Detailed Site Plan Alternative Compliance Dobson Ridge

DSP-20007
AC-21009

SUBJECT: Detailed Site Plan DSP-20007
Type 2 Tree Conservation Plan TCP2-013-2021
Alternative Compliance AC-21009
Dobson Ridge

Figure 4: Sign Elevations

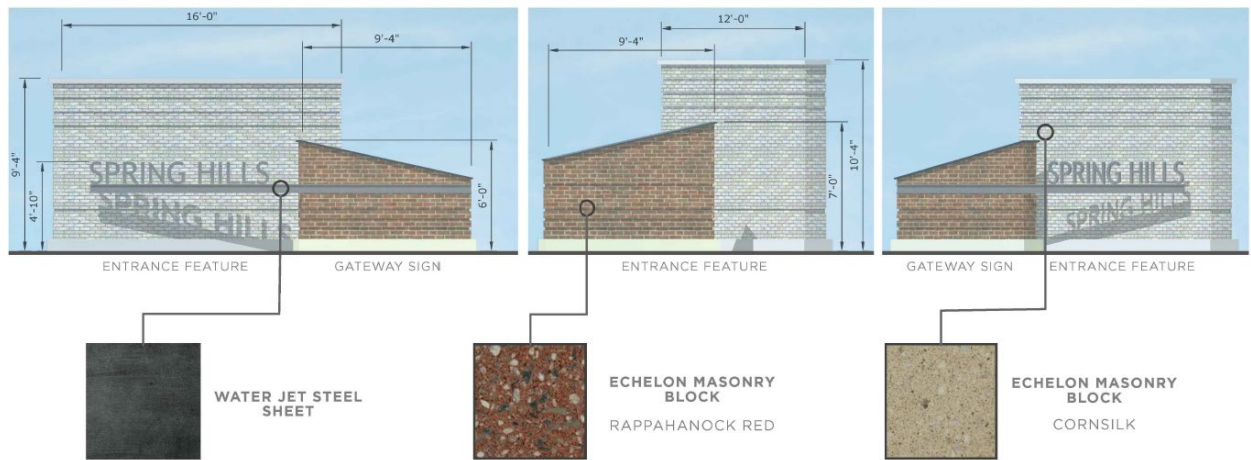
It is unclear if the signs are illuminated, and staff recommends this information be shown, as conditioned herein. In addition, it is also recommended that if the sign is illuminated the lighting not cast glare onto the roadway or residential lots.

- r. Indicate if the gateway sign is illuminated and provide the applicable details.
- s. Provide a brick tracking chart to ensure a minimum of 60 percent of all townhouse units have a full front facade (excluding gables, bay windows, trim, and doors) of brick, stone, or stucco.
